Change in Lead Frame Material

< Affected products: DIP package products of Discrete Division produced at Oita Operations >

Date: June 26, 2015
Toshiba Corporation
Semiconductor & Storage
Products Company

- Solderability Test Data

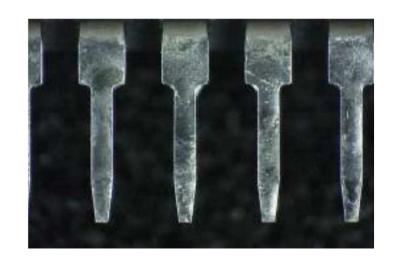
SnAg-PPF [current lead frame]

Pd-PPF [new lead frame]

Test item	Sample size	Test result (reject/gross)
Solderability	12pcs	0/12pcs

- Package Appearance Comparison

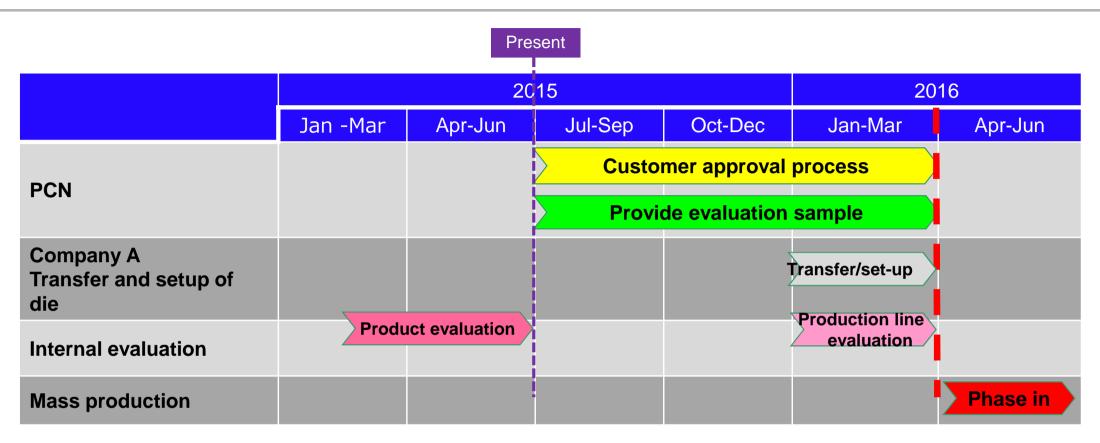
No problem in marking visibility without significant difference from the current package Slight difference in gloss of outer leads is due to difference in plating composition.
